# SH7 (LOWER) PERMANENT PAVEMENT REPAIR PROJECT

VALUE ENGINEERING REPORT

CDOT Project No. ER 007A-023 (20252)

JULY 2020

**VE Proposal P1: One Inch Mill with Two Inch Overlay**

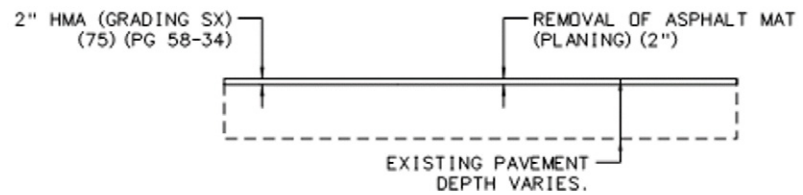
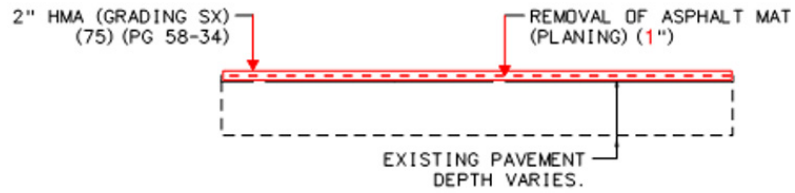
**Description:** One Inch Mill with Two Inch Overlay

Mill 2” of existing pavement and overlay with 2” of HMA.

Mill one inch of existing pavement and overlay with two inches of HMA.

Exhibit P2.1: As Given - Resiliency Paving Section

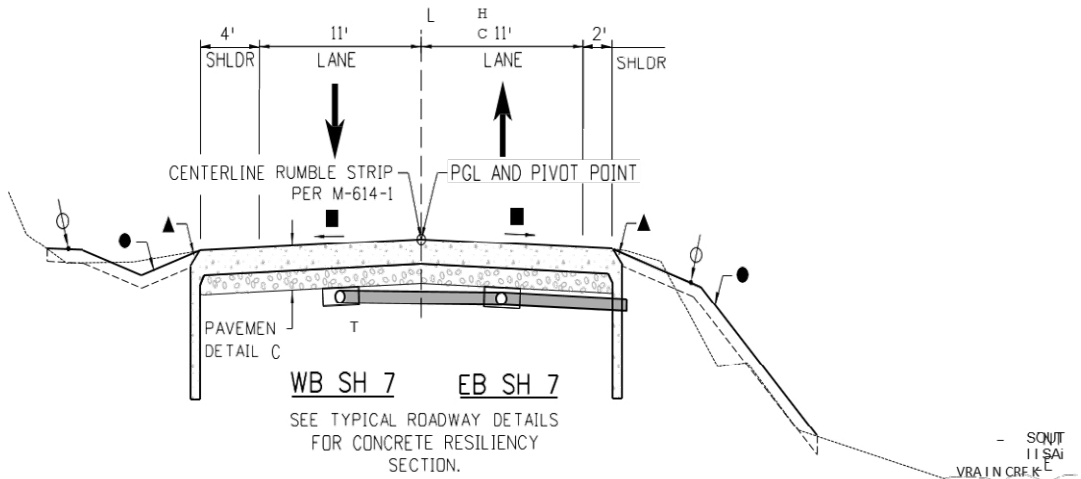
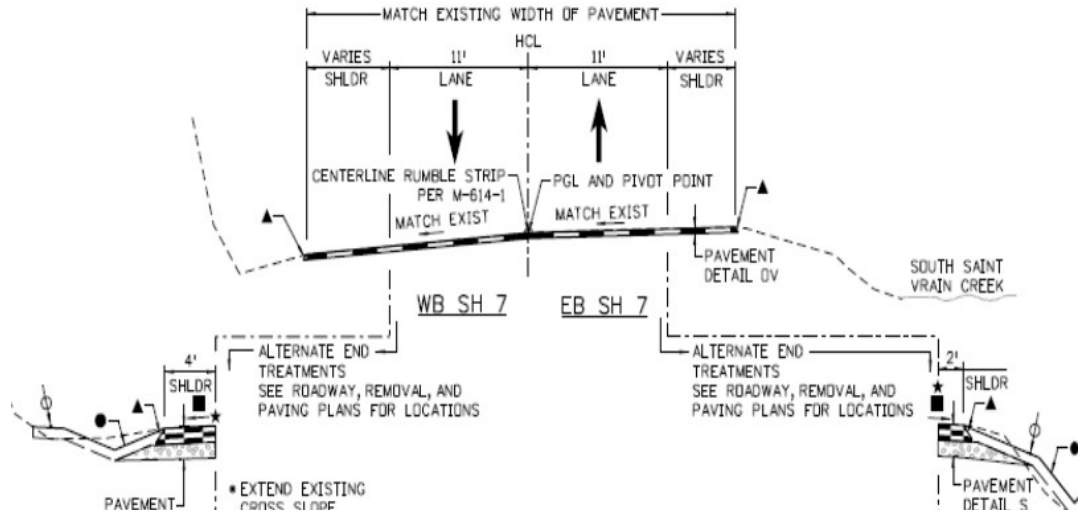
The plans include 10 locations of concrete pavement meant to function as resiliency areas to primarily resist damage from upslope drainage crossing the roadway. These paving sections are 28 feet wide and vary in length from 300 LF to 600 LF. Dimensions for the toe-walls were not provided but are assumed to be about 8 feet deep and 6 inches thick based on scaling in the detail..

The proposed paving section matches the shoulder widening and mill and overlay sections of other sections of the project.

Exhibit P3.1: As Given -

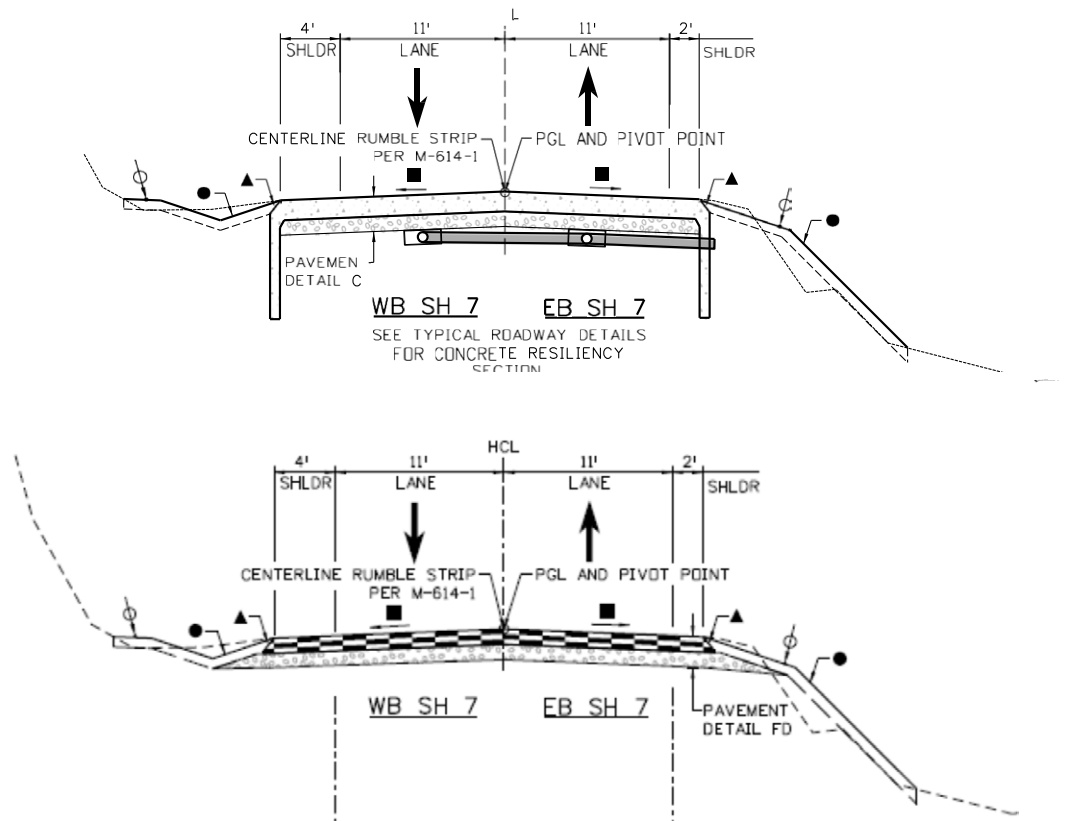
The plans require ABC Class 6 under all reconstruction sections including locations with shoulder widening. It was not noted in the plans where RAP was allowed in the ABC Class 6 although it is typical that Region 4 is reluctant to allow its use. Removal of HMA (Planing) is currently planned at approximately 7,872 CY of millings. In addition, removal of HMA is currently planned at approximately 7,889 CY. This results in a total of 15,761 potential cubic yards of RAP available for use in ABC CL 6. See example typical sections below:

Exhibit P5.5: CTS Typical Section

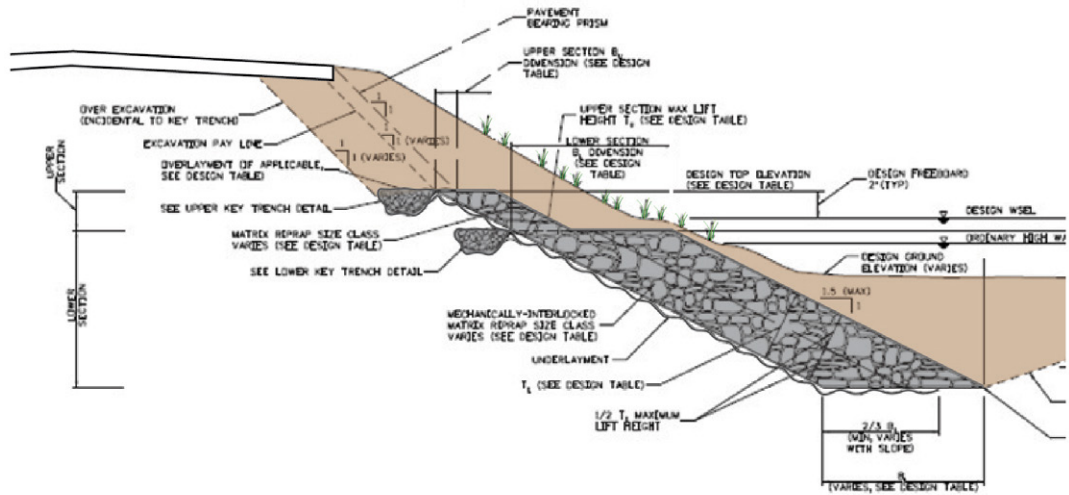
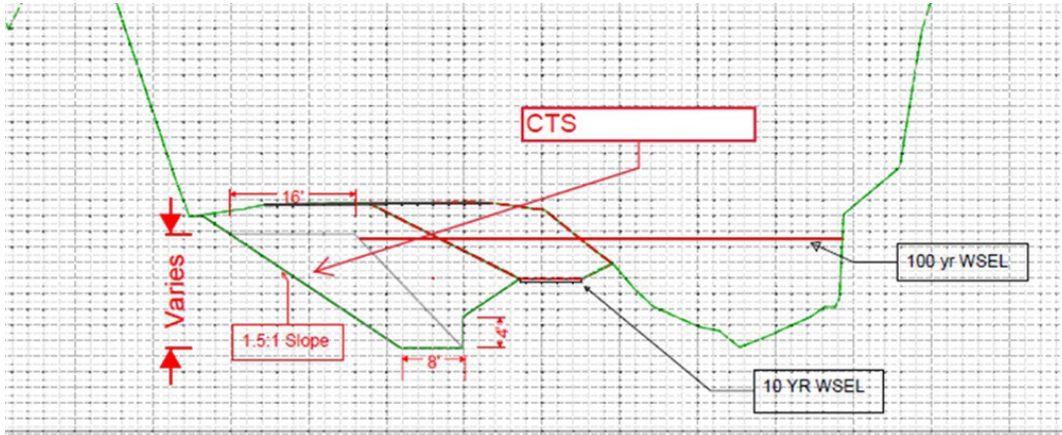
Matrix riprap is a tested and proven slope armament treatment, however, it is very difficult to construct in confined canyon environments, especially if during the wintertime. There are extensive quality assurance/control requirements to ensure that it is installed correctly.

Installation of matrix riprap at the proposed locations will likely require to temporally divert or pipe the river, which will cause a great disturbance to the riparian habitat at these locations. Dewatering and monitoring of water quality is very challenging as well.

- In a flood event, it is anticipated that the roadway section would be washed away, leaving the CTS section, with a 15' traversable surface. The traversable surface would allow emergency ingress/egress for through traffic, locals, emergency responders. It would also allow for rapid mobilization of construction crews in the case of the next flood event.

There is a chance that a one-way bypass road could be built to allow traffic by in most locations of the construction, shown in the x-section in Exhibit P5.5.

Exhibit P6.3: As Given MP 29.8

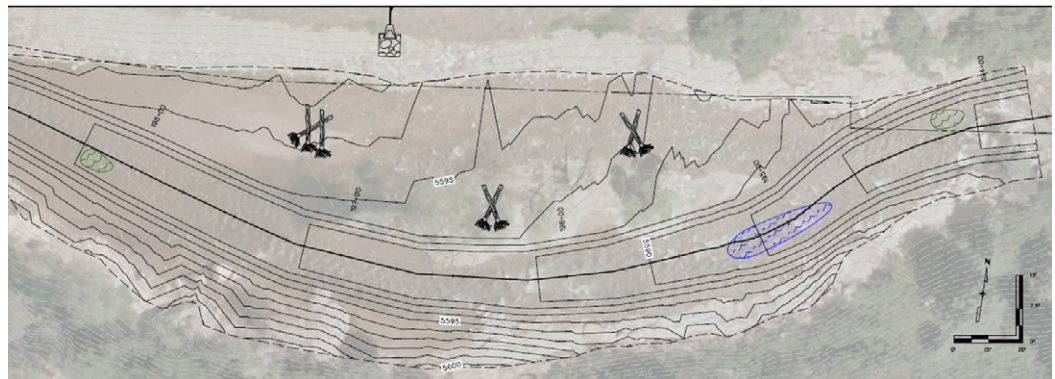
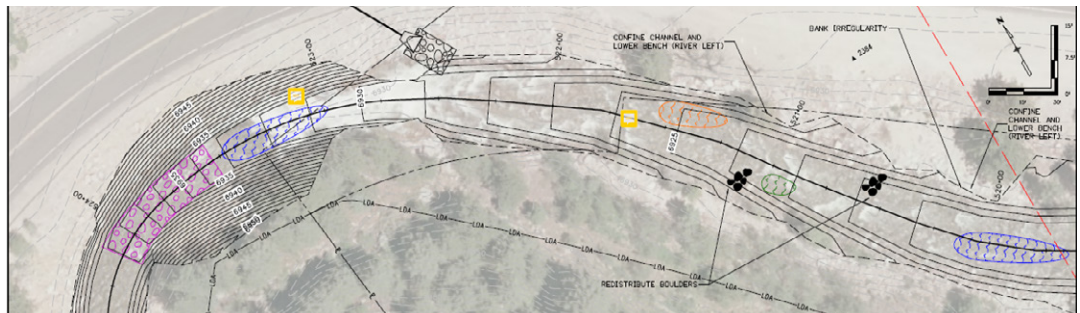
As proposed the work includes major grading throughout the corridor, the removal of mature trees, and removal of established and existing riparian vegetation. The work, as proposed, will be a full reconstruction of the creek bed, banks, and floodplain. Secondary channels will be filled. There are no major changes to main channel geometry or slope.

This approach takes advantage of on-going, beneficial stream processes to maximize long-term benefit while reducing heavy civil construction, civil construction costs, and maintenance considerations. This proposal is to replace the majority of, or all of, the proposed streamwork with an intensive revegetation plan. This is not a recommendation for a standard revegetation or general landscape planting plan. This is a recommendation for the foundation of the stream design to shift toward using vegetation to drive geomorphic responses that will naturally build the channel, floodplain, in-stream habitat, and induce vegetation succession. This proposal also includes a recommendation for bioengineering for bank stability, where necessary.

Exhibit P7.3: As Given MP 29.8

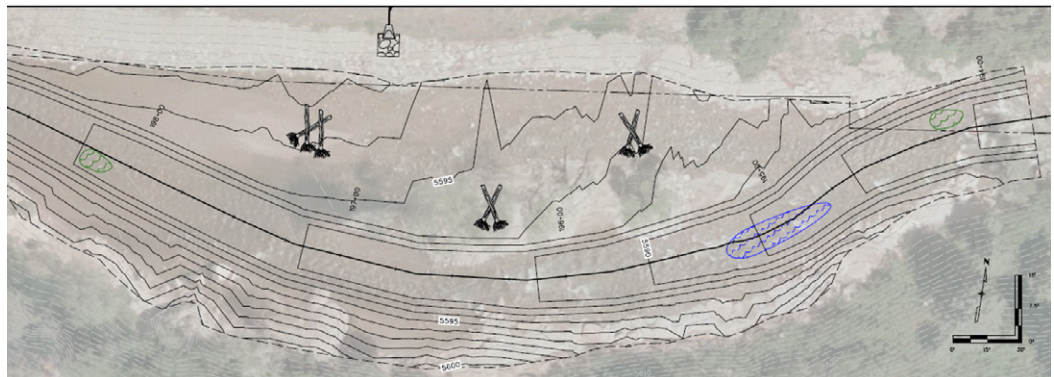
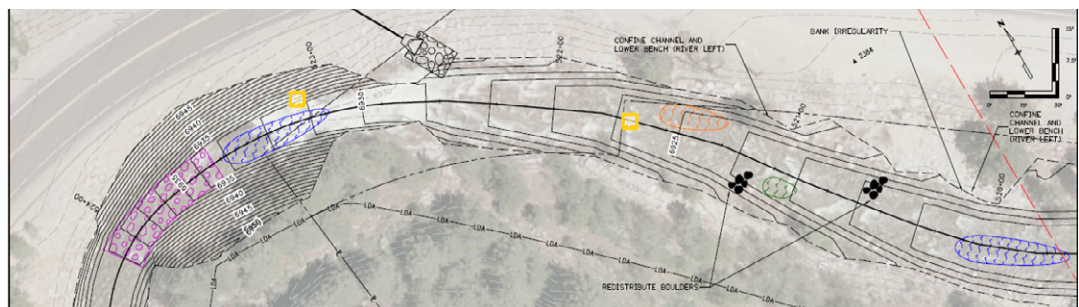
As proposed the work includes major grading throughout the corridor, the removal of mature trees, and removal of established and existing riparian vegetation. The work, as proposed, will be a full reconstruction of the creek bed, banks, and floodplain. Secondary channels will be filled. There are no major changes to main channel geometry or slope.

This proposal also would eliminate the majority of the tree removal and the vegetation removal that is currently shown on the plan set. It also removes all boulder cascades and structural riprap and greatly reduces the number of drops.

Exhibit DS3.1: Aggressive Schedule

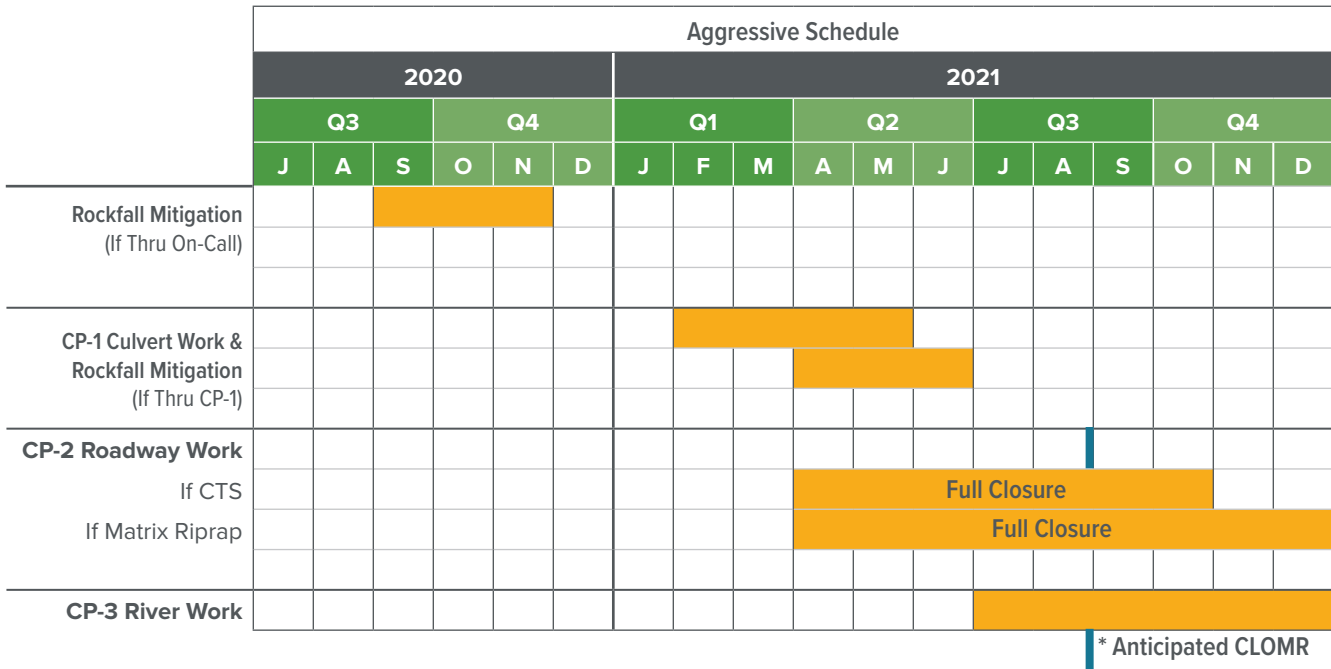
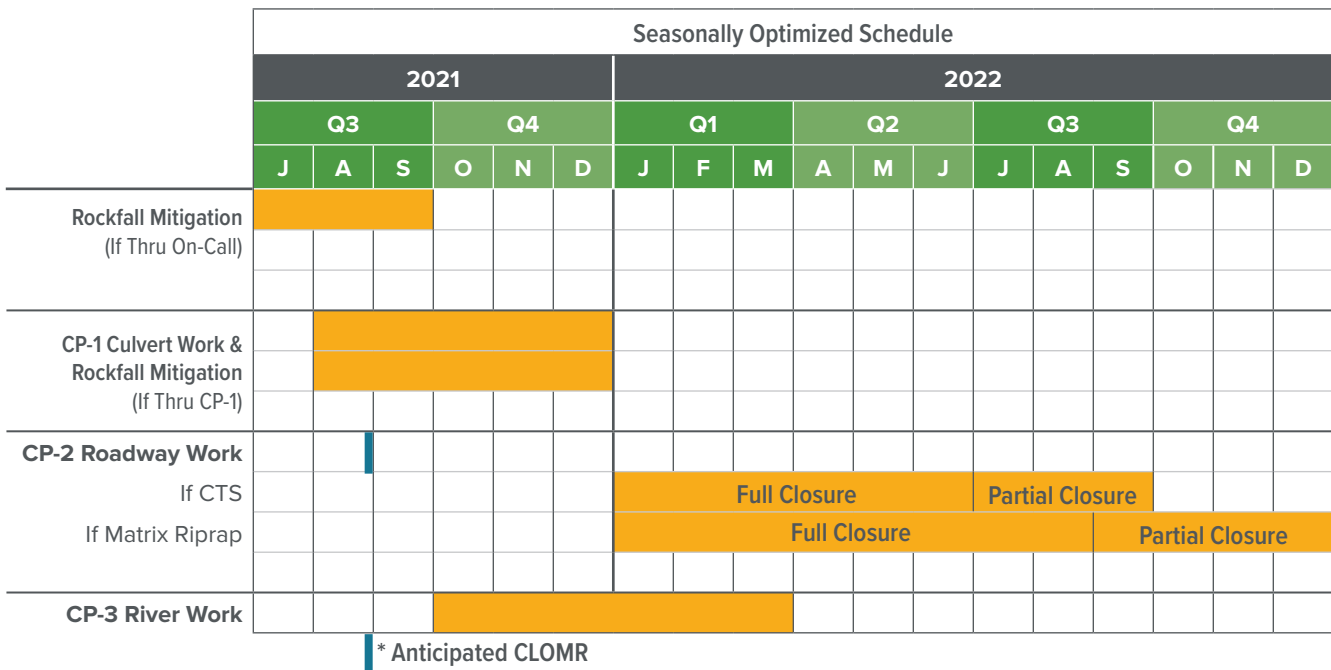
- Culverts in resiliency sections should be completed at the time of the resiliency work
- Kiewit needs to verify if after CP1, they would be able to complete the CP2 work in nine months
- Need to verify durations for weather sensitive items
- Culverts in CTS (if change is made), would be in CP2

- Risk related to CLOMR timing is increased
- Risk of gap in work is increased (ROW, agency approval/ permitting, etc.)
- CLOMR September 2021
- Preferable to do rock mitigation work after winter
- River work after peak flow (i.e. Q1/Q2)
- Rockfall may be able to be subbed to existing “on-call” contractor(s)
- Roadway work will have “no work” areas
- Culverts will have “no work” areas

*Exhibit DS5.1: Photo of current slope conditions from a maintenance request after a rockfall that occurred in April on SH7 near MM 23.4*

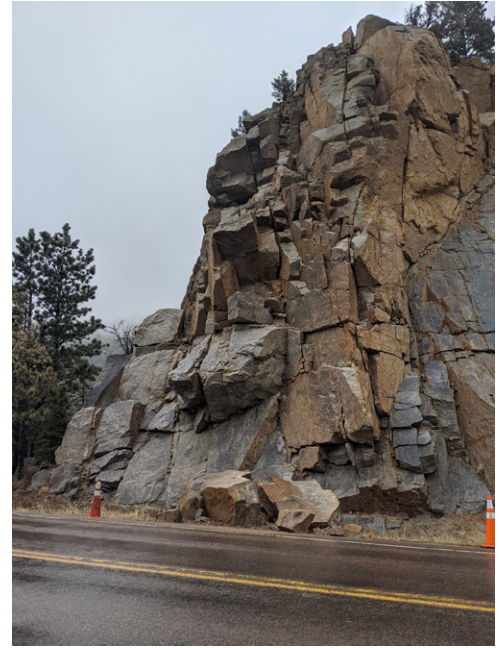
It's recommended that rockfall mitigation sites be prioritized by maintenance needs. They can provide valuable information on common occurrences, and in areas where debris commonly accumulates after storms. See Exhibit DS5.1.
